# HEAVY VEHICLE LOCAL ROAD REPORT SITE ESTABLISHMENT

Sydney Metro West – Western Tunnelling Package

Document Title	<b>Parramatta Heavy Vehicle Local Road Report Site Establishment</b>
Project Name	<b>Sydney Metro West – Western Tunnelling Package</b>
Client	<b>Sydney Metro</b>
Document Reference No.	<b>SMWSTWTP-GLO-PTA-HS-RPT-000001-A.01</b>
Revision Date	<b>7 June 2022</b>

# REVIEW COMMENTS SHEET

Figure 7-2: Swept path analysis locations for site establishment phase of works

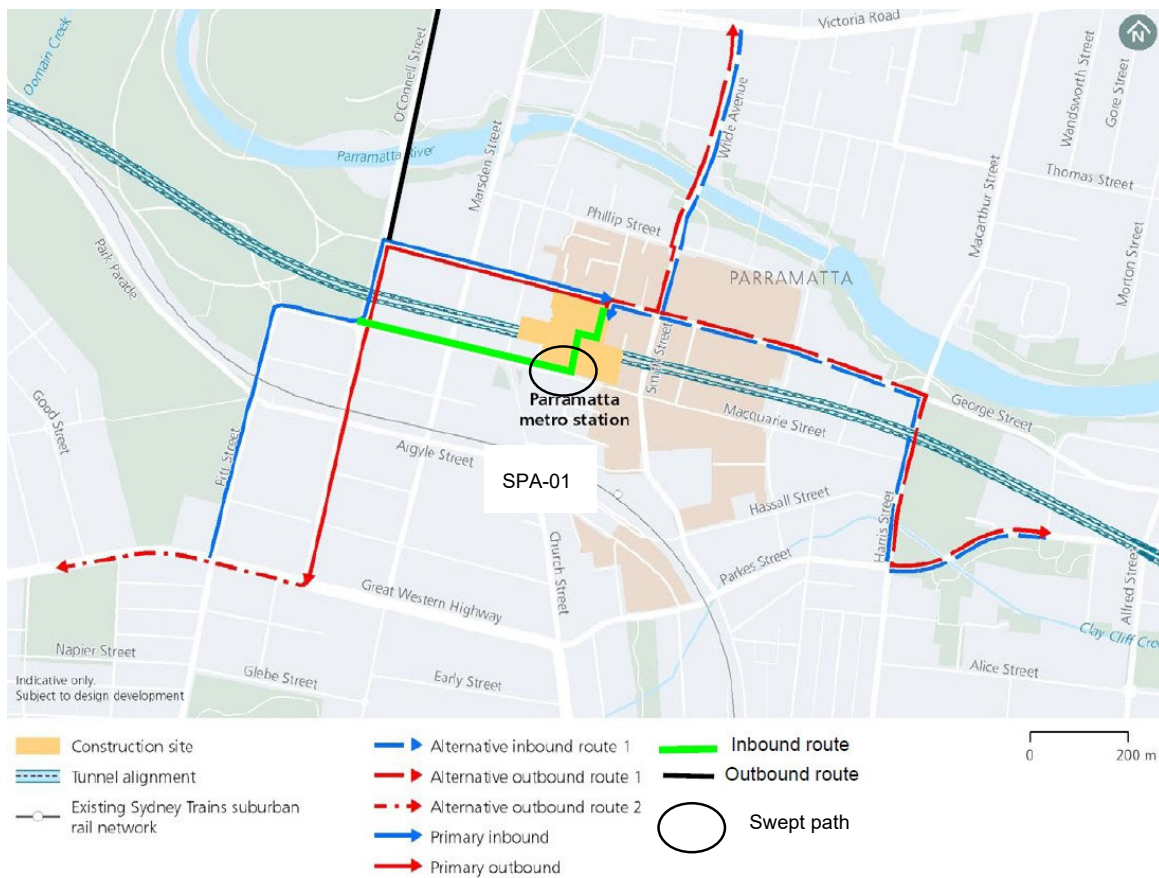
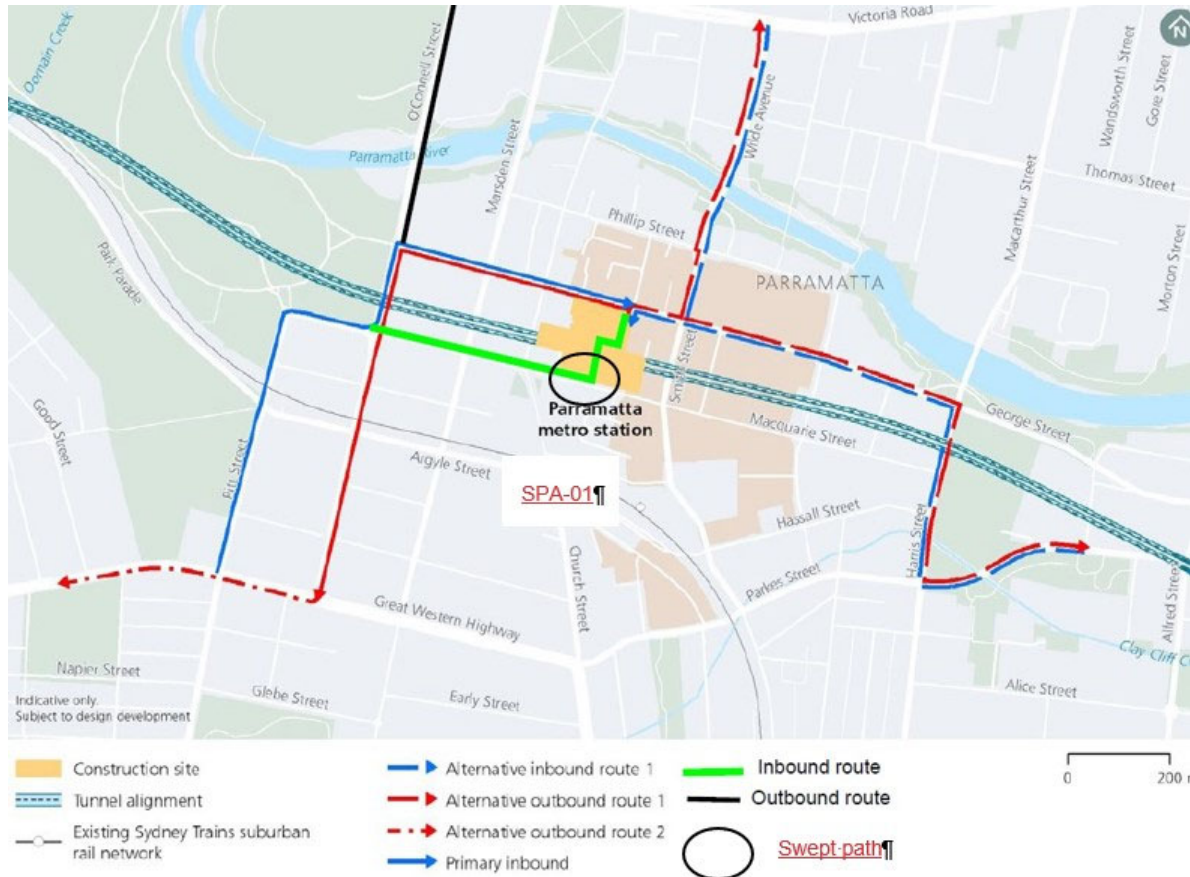
08.01.01	27/05/2022	TFN	LWILBY				Response noted, comment closed.	Observation	Y
												Observation	Y
				09	9/05/2022	SMD	BGORDON	SMWSTWTP-GLO-PTA-TF-RPT-000001	Flgure 7.2	MCoA D87	Figure 7-2 and 8-1 show the same inbound route for heavy vehicles. The outbound route/s for heavy vehicles, are two lines at the bottom of the first paragraph in Section 7.3. To improve clarity consider one map shewing all routes, maybe even an overlay of inbound and outbound routes over the EIS route map, allowing a clear comparison.	Observation	N
								SMWSTWTP-GLO-PTA-TF-RPT-000001	Flgure 7.2	MCoA D87		Observation	N

09.01	24/05/2022	GLO	DKELLY	SMWSTWTP-GLO-PTA-TF-RPT-000001	Flgure 7.2	MCoA D87	No change to document as it is quite clear what swept paths are being undertaken	Observation	N
							DKELLY	SMWSTWTP-GLO-PTA-TF-RPT-000001	Flgure 7.2	MCoA D87	Document amended	Observation	N
				11	16/05/2022	SMD	SCLARKE	SMWSTWTP-GLO-PTA-TF-RPT-000001	Definitions/ Abbreviations	N/A	Update DPIE to DPE	Observation	Y
								SMWSTWTP-GLO-PTA-TF-RPT-000001	Definitions/ Abbreviations	N/A		Observation	Y

Drawing #	Location	Suitability	Truck type
PTA-SPA-01S	Macquarie Street into Horwood Place	Yes	19m Semi-trailer
PTA-SPA-01T	Macquarie Street into Horwood Place	Yes	19m Truck and dog

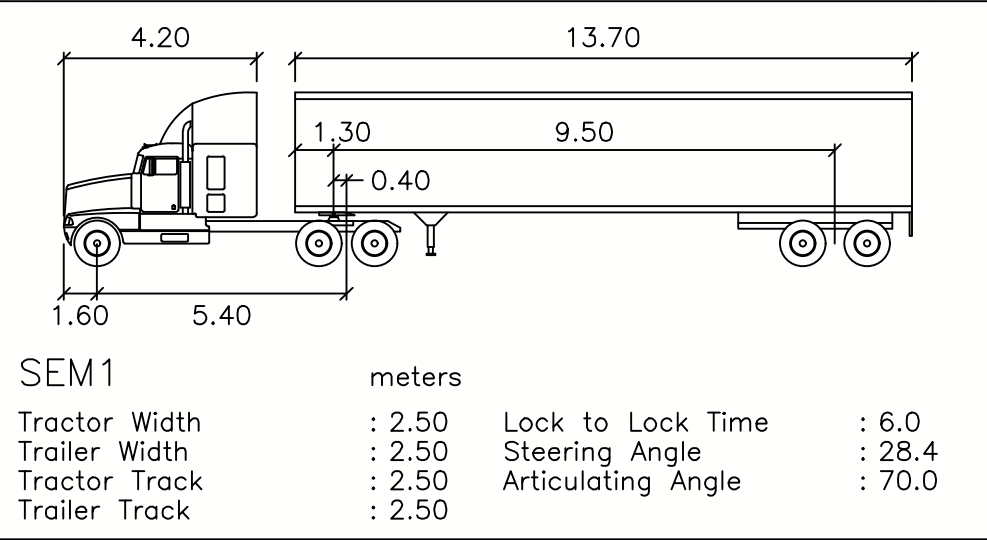
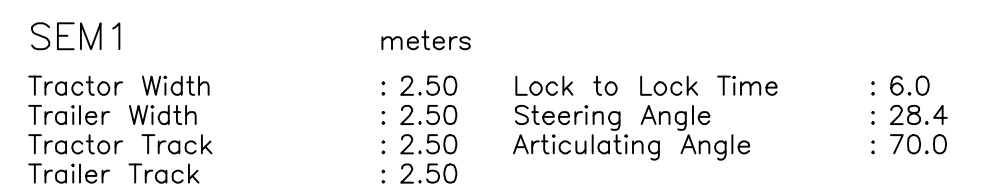
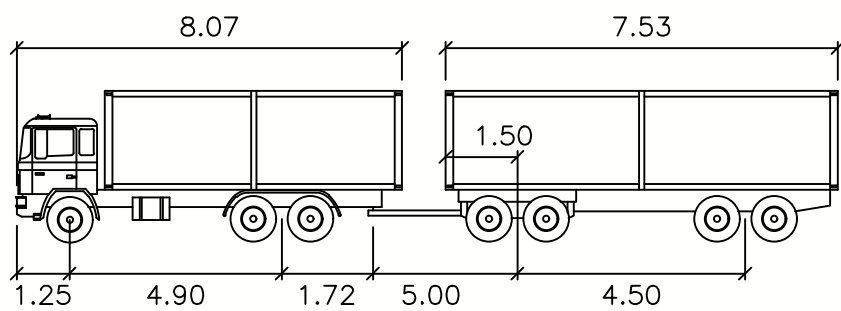
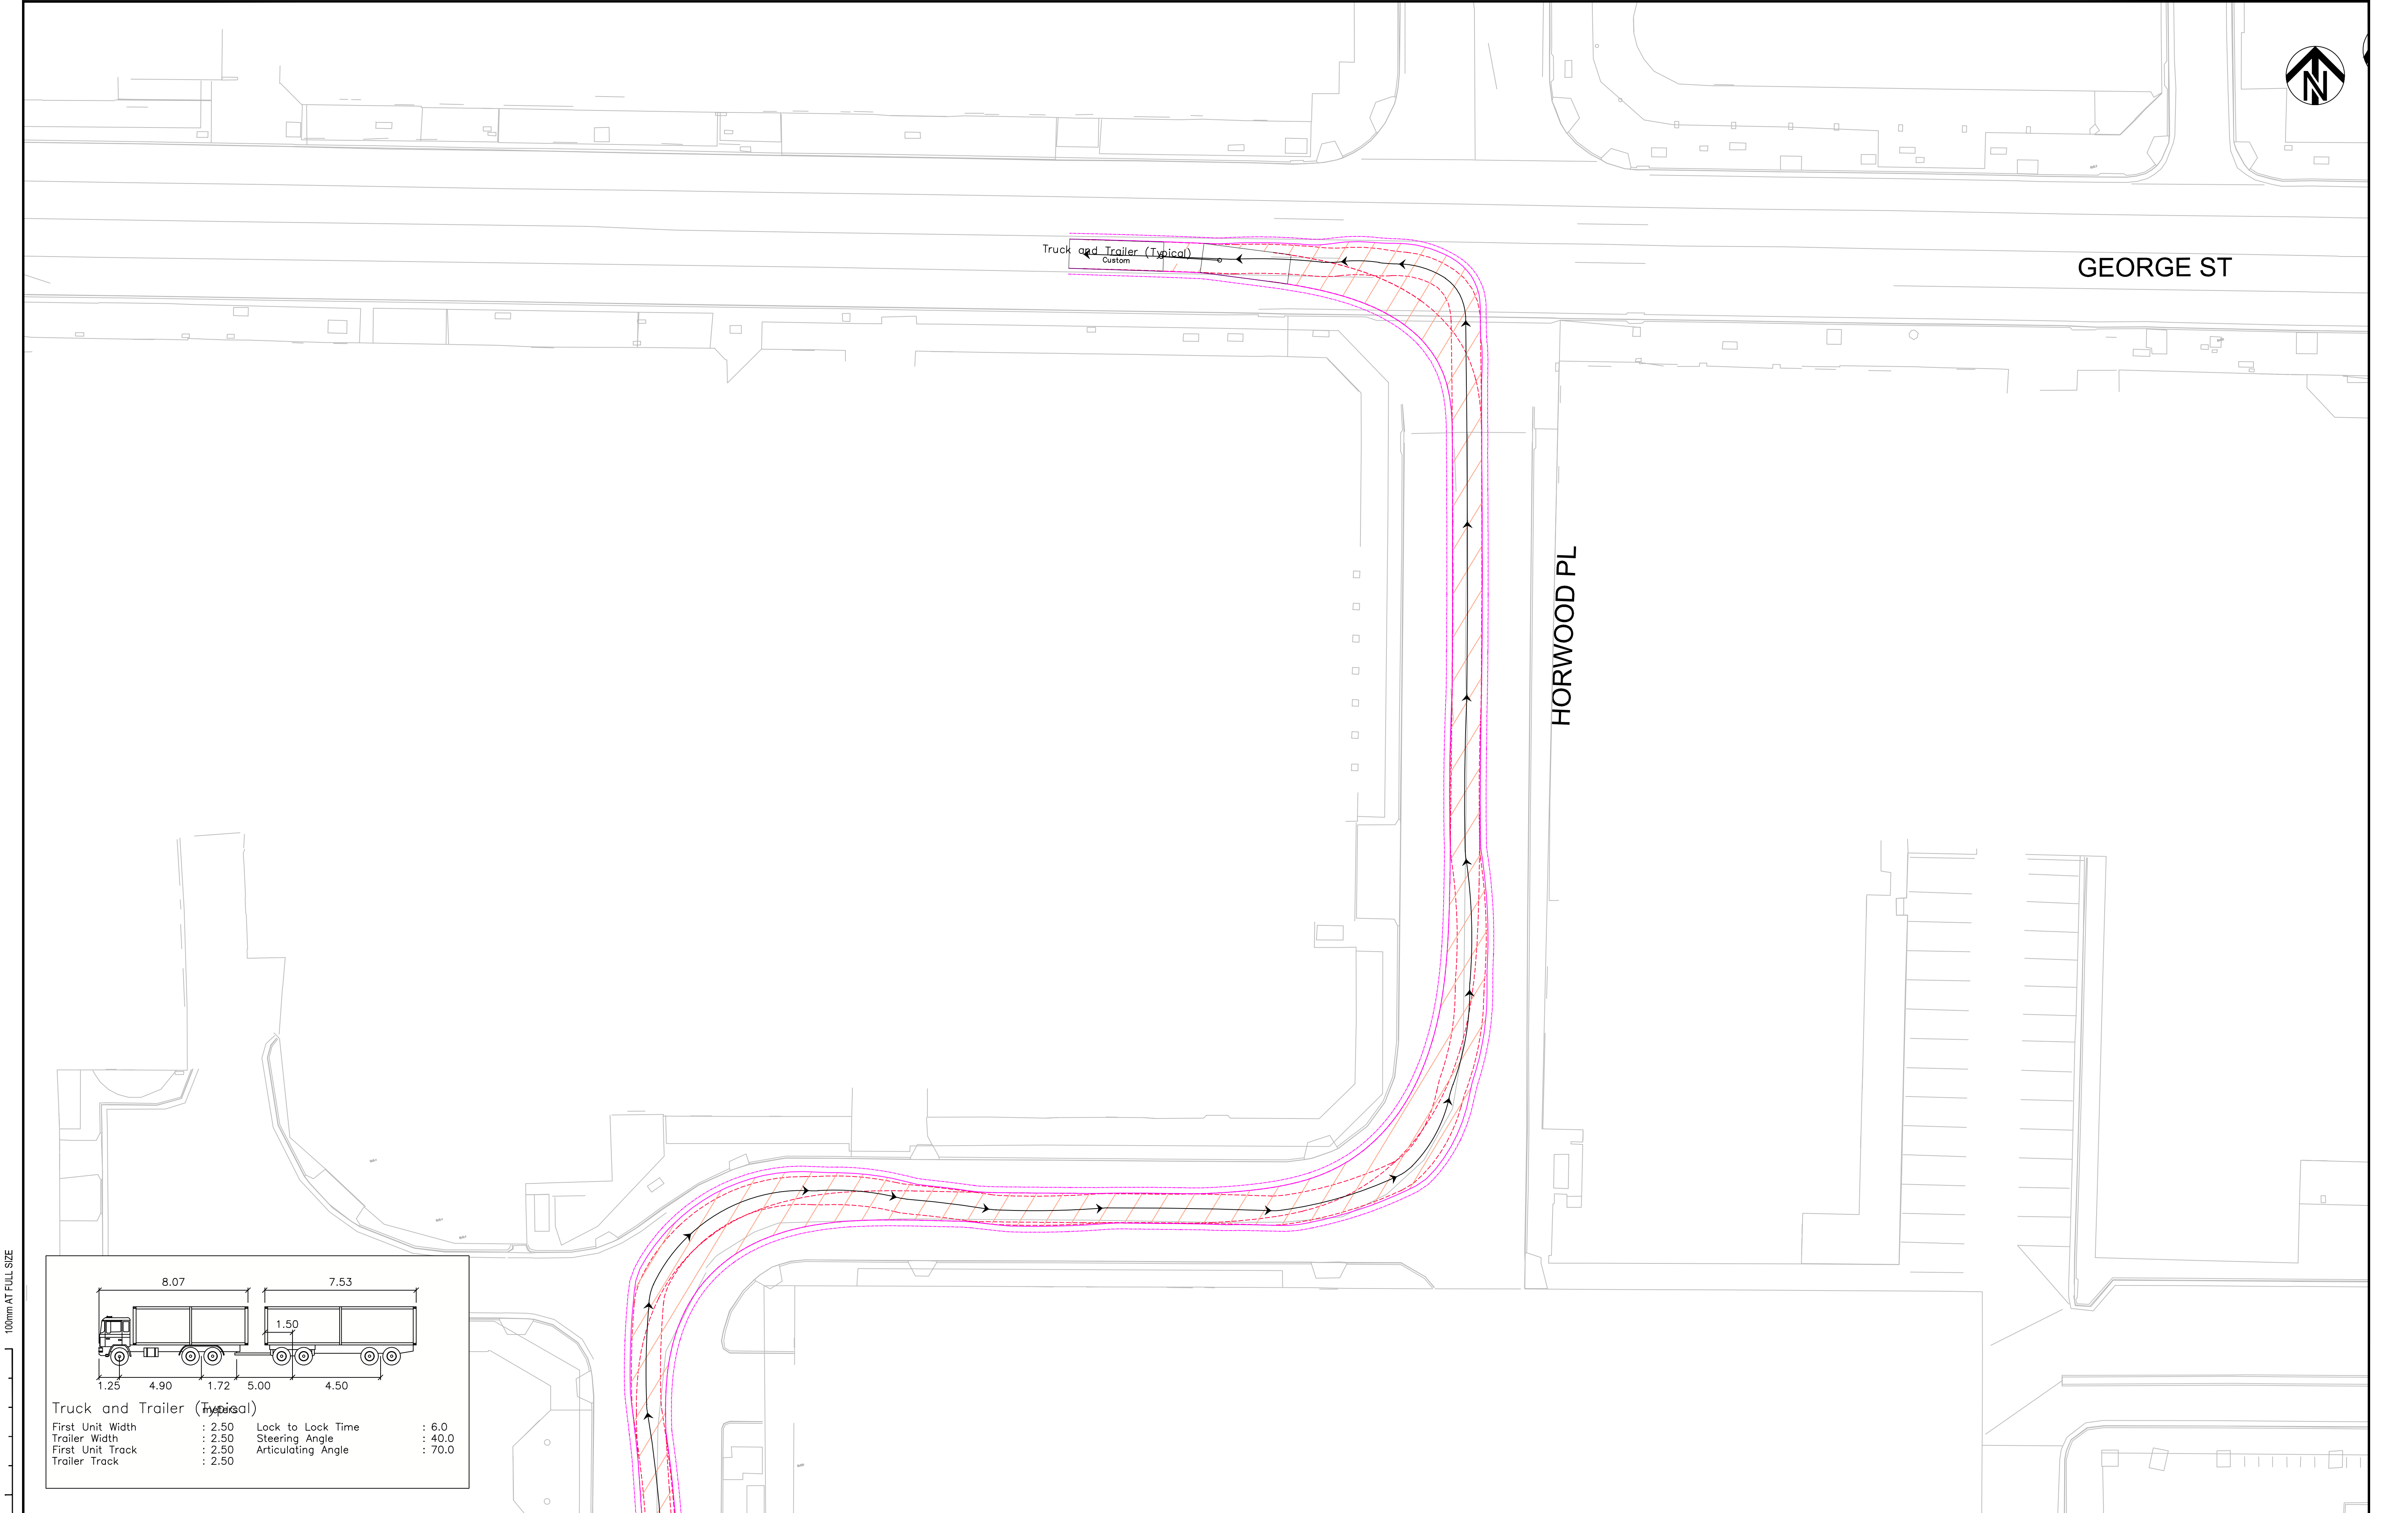
DOCUMENT NO.	TITLE	VER	STATUS	NO.	DATE	COMPANY	RAISED BY	REVIEW DOC. NO.*	DOCUMENT REF*	DEED REF*	COMMENTS / RESPONSE	COMMENT CATEGORY*	CLOSED OUT
				08	9/05/2022	TFN	LWILBY	SMWSTWTP-GLO-PTA-TF-RPT-000001	A: Swept Path Analysis	NA	The swept path for both vehicles from the left turn movement from Horwood into George Street indicates that they will either overhang the centre line or leave very little margin for error. This increases the risk of head on collision with vehicles travelling along George Street. Please consider and demonstrate what else can be reasonably done to prevent collisions in this location.	Observation	Y
								SMWSTWTP-GLO-PTA-TF-RPT-000001	A: Swept Path Analysis	NA		Observation	Y
